BOARD OF APPEALS, CITY & COUNTY OF SAN FRANCISCO

Appeal No. **26-044**

NOTICE OF APPEAL

The substance or effect of the decision or order appealed from is the ISSUANCE on August 7, 2026 to Irene Situ Qunai, of an Alteration Permit (3' landing in front of side door at first floor; 199 square foot concrete in rear yard; to comply with Notice of Violation No. 2026059762) at 462 Ramsell Street.

EXHIBIT 5 — CURRENT REAR-YARD CONFIGURATION

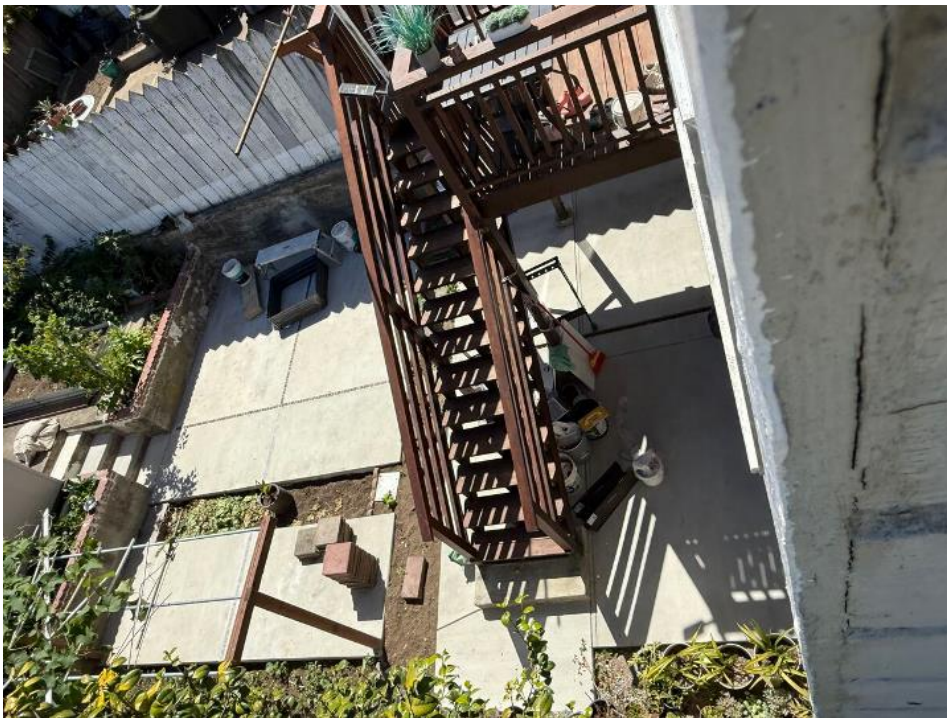
Current panorama shows the lower yard is predominantly concrete and enclosed on three sides (house and two taller retaining walls). The downhill fence and retaining wall are not visible.

The surface area of new concrete and new corrective soil strips are visible. The downhill fence and retaining wall are not visible.

EXHIBIT 7 — CORRECTIVE SOIL STRIPS

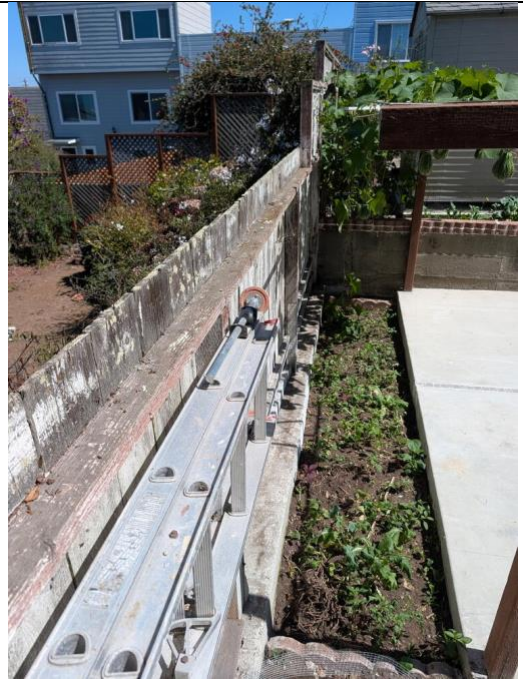
Soil strip sawcut after the correction along lower retaining wall.

Soil strip current condition along lower retaining wall.

EXHIBIT 12 — RETAINING WALL & NEIGHBORING RETAINING WALL EDGES

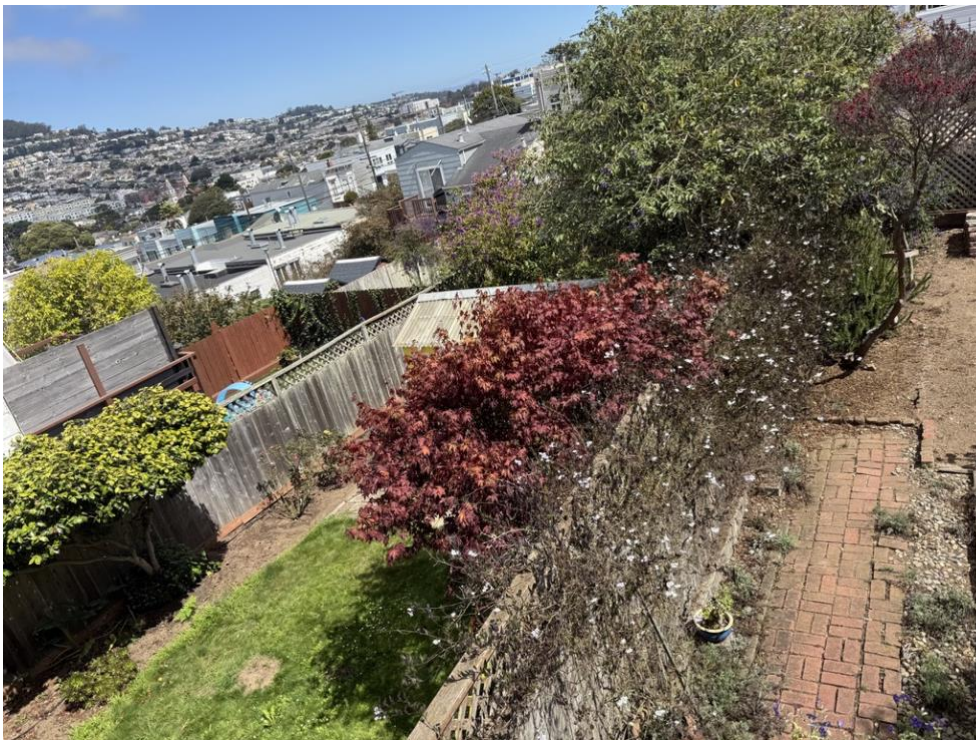
Two tier retaining wall as seen from Appellant's rear yard. Concrete slurry whitening/bleaching visible.

Elevation difference between yard and retaining wall edges/lip at 466 and other downhill properties. The edge elevation is several inches above the yard elevation in other neighboring yards.

Exhibit R-18

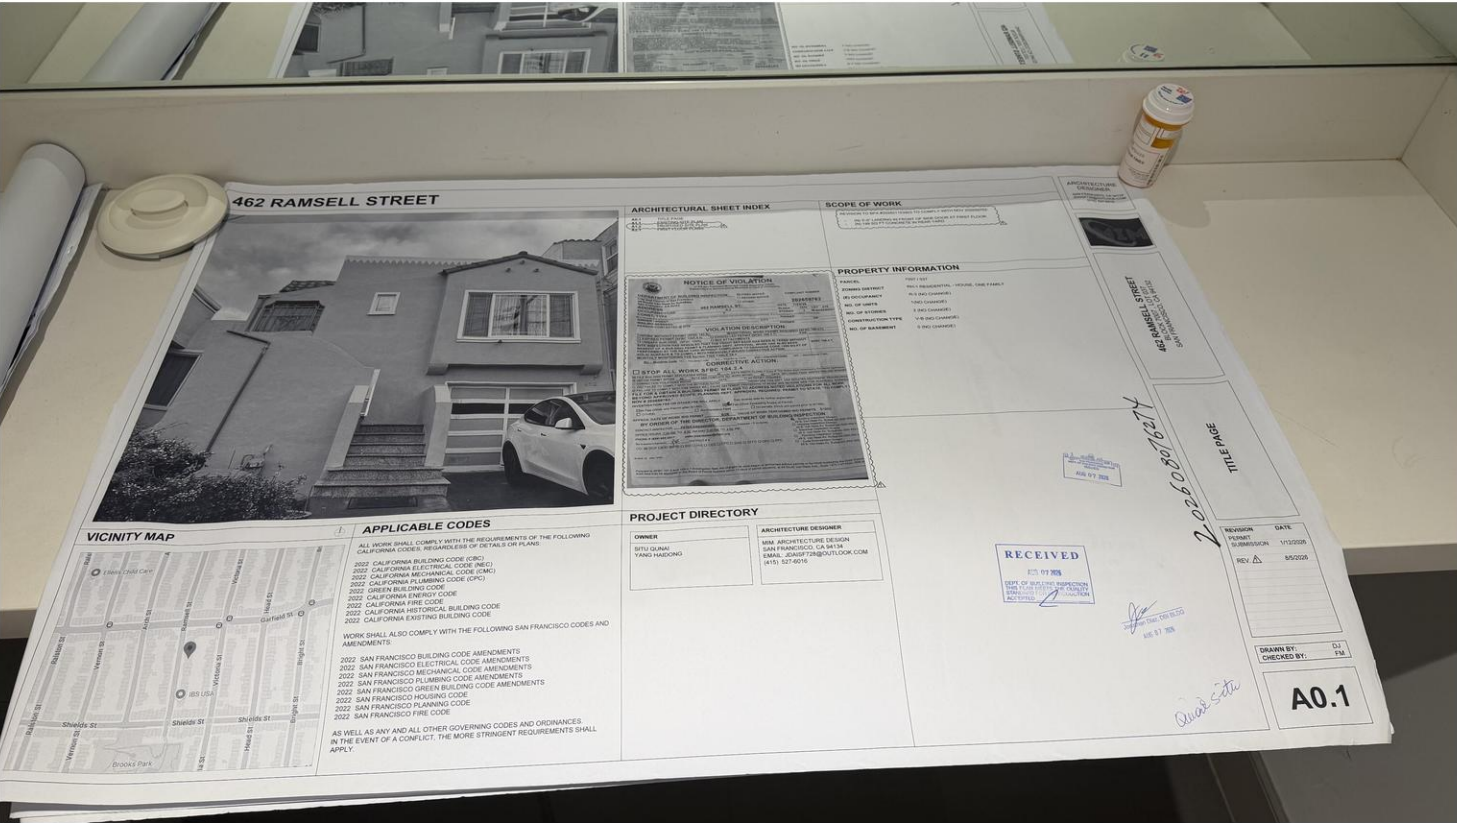
Approved Proposed Site Plan (Sheet A1.2): the two new rear-yard concrete areas (141 sq. ft. and 58 sq. ft., totaling 199 sq. ft.) separated by planter areas, the 3-ft landing, and DBI/Planning stamps. Plan note: new rear-yard concrete shall not exceed 199 sq. ft.

Exhibit R-21

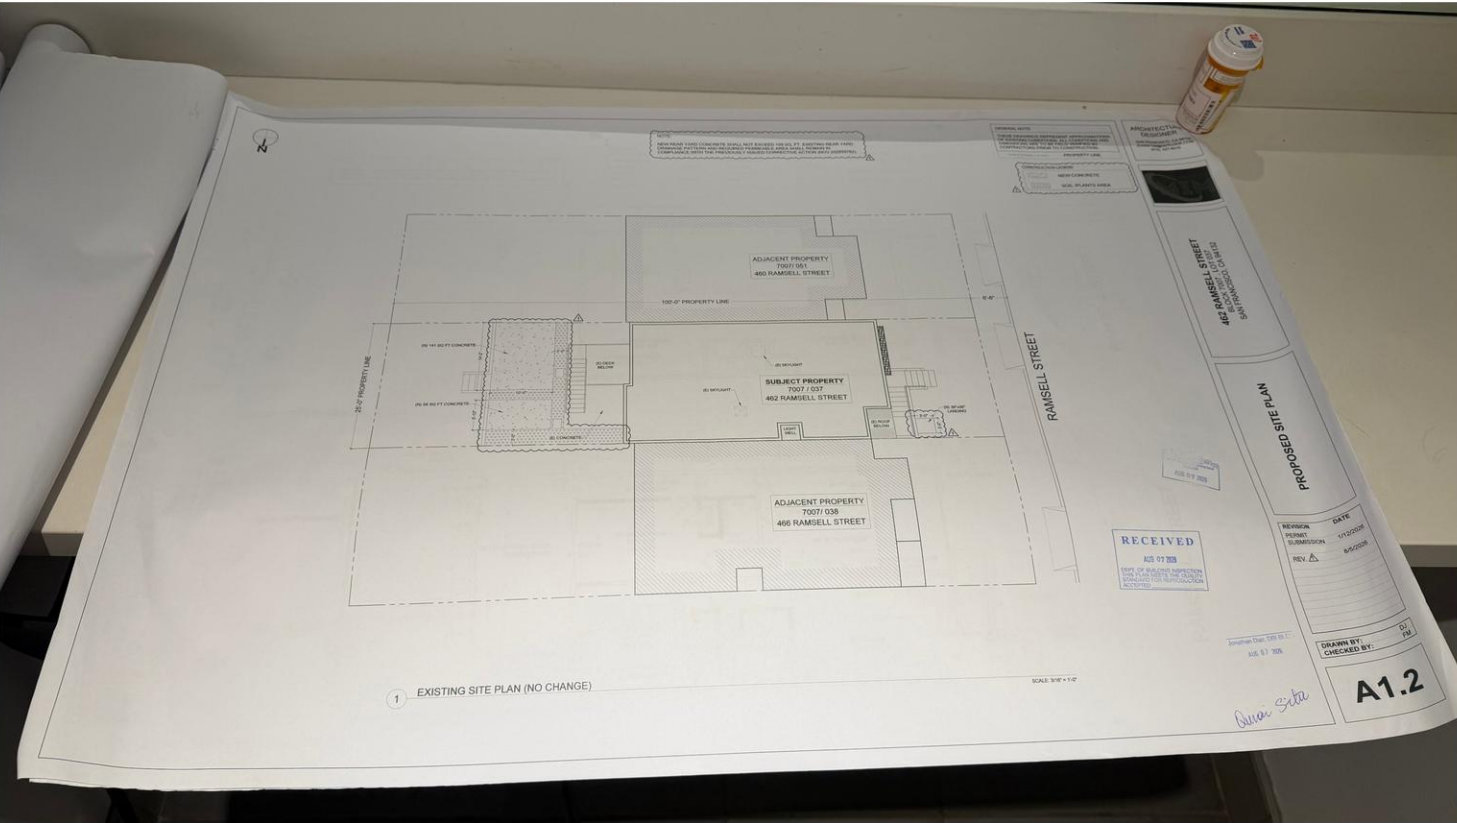
Approved Proposed Site Plan (Sheet A1.2) for Permit No. 202608076274: the two new rear-yard concrete areas (141 sq. ft. and 58 sq. ft., totaling 199 sq. ft.) separated by planter areas, and the 3-foot side-door landing; DBI-stamped August 7, 2026. (Photograph rotated 180° for readability.)

1. Sheet A1.2 Proposed Site Plan was not an original plan sheet in PA# 2026-0115-3903 and should have been clouded and provided with a delta to identify the sheet as a newly added plan sheet since this was a revision to the previously issued permit.
2. Sheet A1.2 is labeled as "Proposed Site Plan" in the title block and the proposed site plan shows the changes to the rear yard hardscape/patio area and new landing in the front at the side door, yet the title of the site plan on the sheet is noted as: Existing Site Plan (No Change). The Proposed Site Plan clearly shows proposed changes, as compared to the Existing Site Plan shown on Sheet A1.1.
